# AMERICAN UNIVERSITY 2021 CAMPUS PLAN

## Comprehensive Transportation Review

Including Addendum 1 (October 28, 2020)

Addendum 1 - October 28, 2020 .....	12-70
-------------------------------------	-------

Figure 2-4: Transit Network & Shuttle Routes

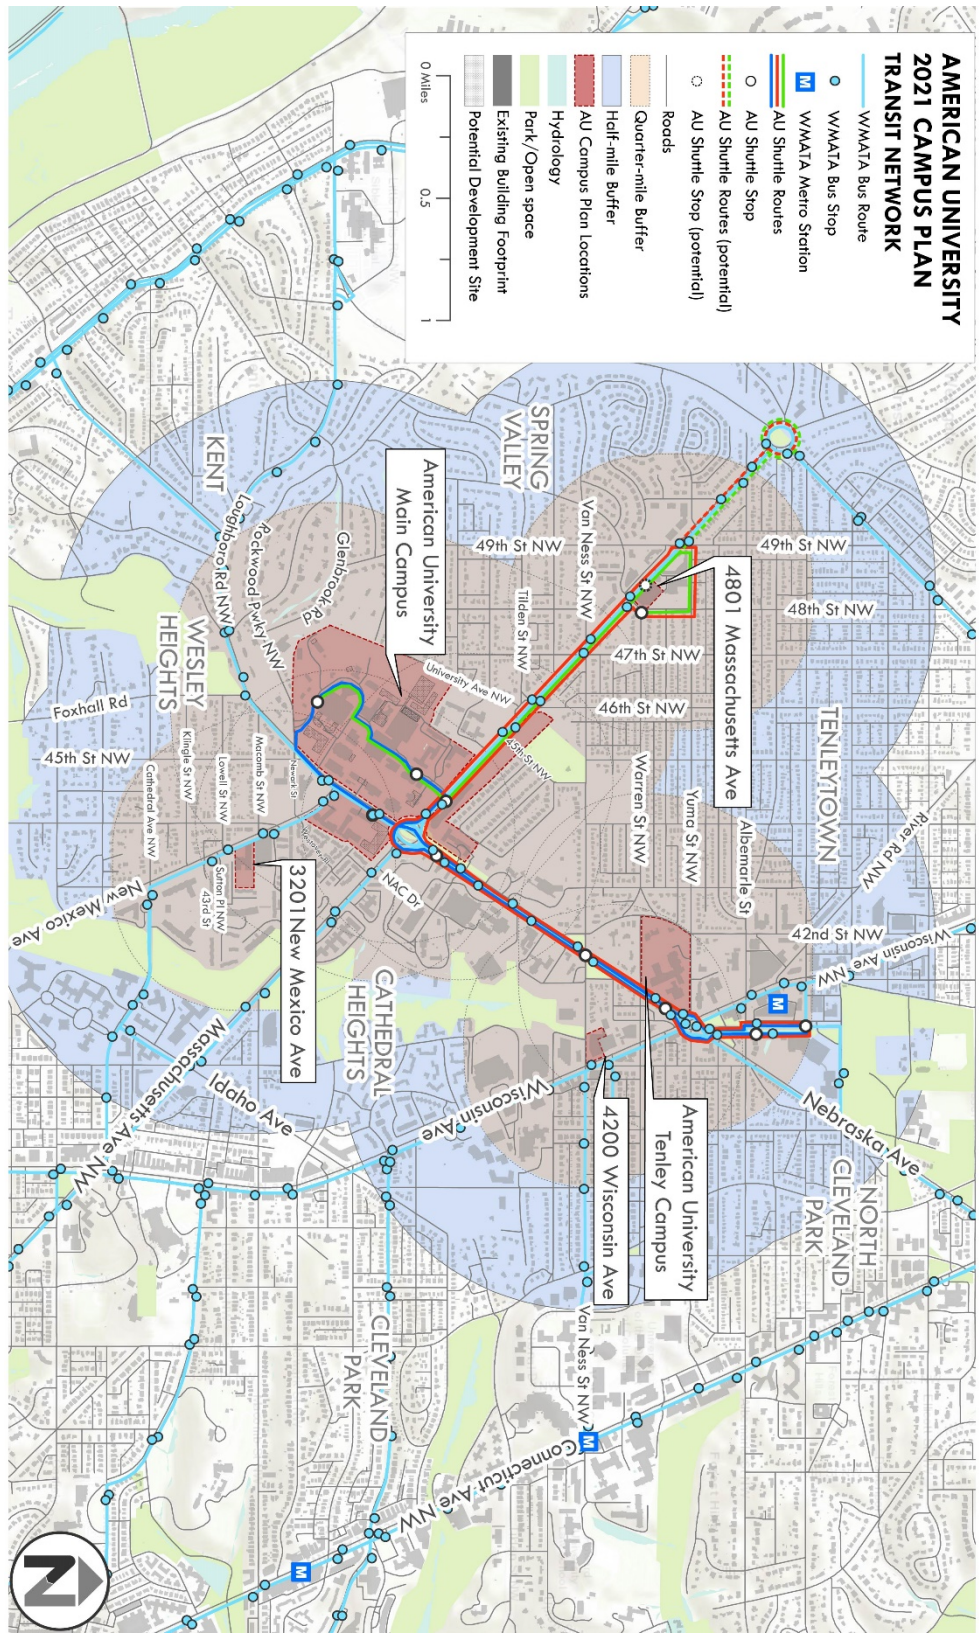
- a. The final sentence of the second paragraph has been updated as follows: “The 2021 Campus Plan does not include any proposed changes to the University shuttle service routes; **however, at the request of ANC3E, AU is currently pursuing a change to the location of the Spring Valley Building bus stop on the Red Route from 48<sup>th</sup> Street, NW to in front of 4801 Massachusetts Avenue, NW to alleviate the need for shuttles to utilize the neighborhood streets.**”
- b. Figure 2-4 has been updated to illustrate the proposed route and stop location.

Figure 3-3: Proposed Campus Circulation

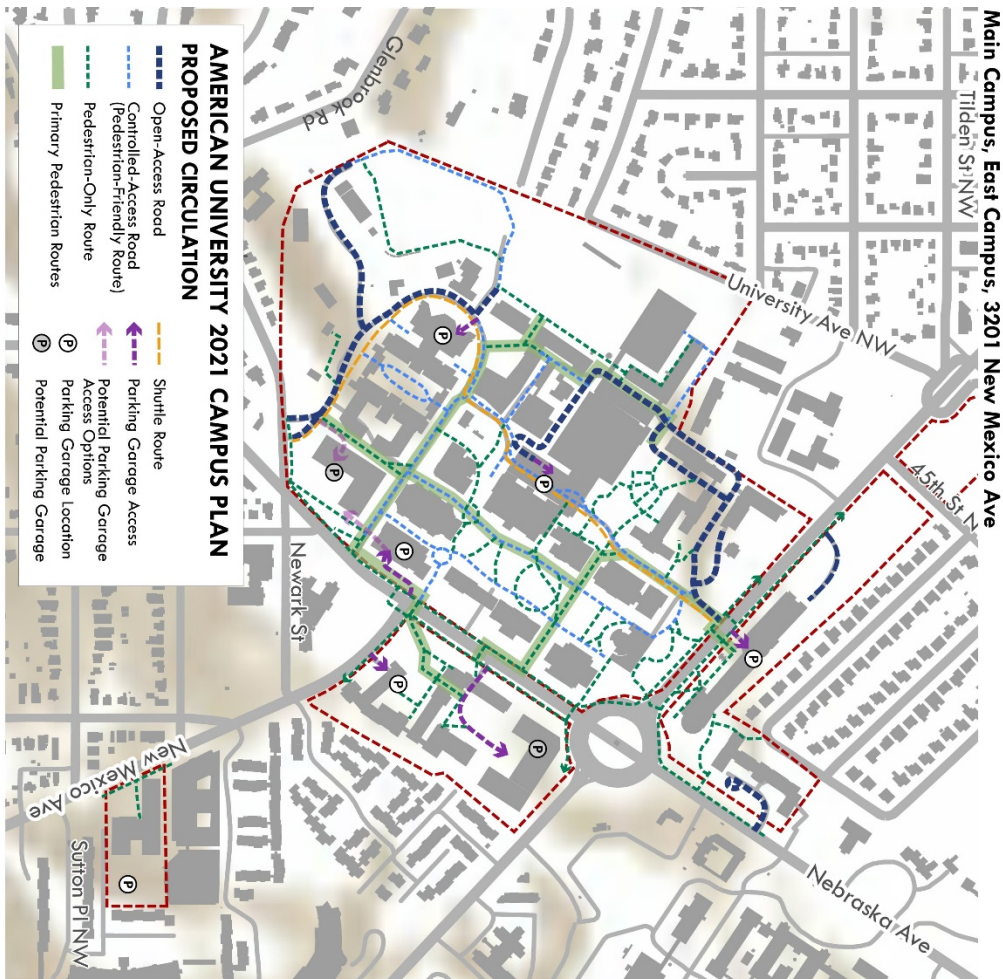
- a. Figure 3-3: Proposed Campus Circulation has been updated to reflect access options associated with the potential below-grade parking on Site 11/12. The preceding paragraph on page 3-21 has been updated as follows: “**In addition, as discussed in the 2021 Campus Plan, garage access options for potential below-grade parking at Site 11/12 will be subject to further review and consideration at the time of further processing.**”
